BOARD OF PUBLIC WORKS

Subject: Notice of Noncompliance (NON) resulting from site visit for the closed CE Land Landfill located at 512 East Ann Street, City of Kaukauna, Outagamie County, Wisconsin, DNR License No. 0073

COMPLIANCE MONITORING
AND EVALUATION FORM

Photo # 82602 Photo 2 of 10

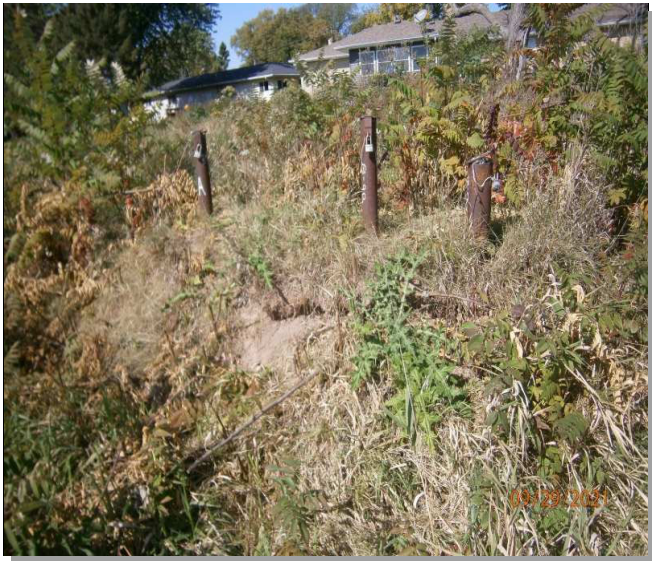
Photo Description
example of monitoring wells that are locked, labeled, and secured
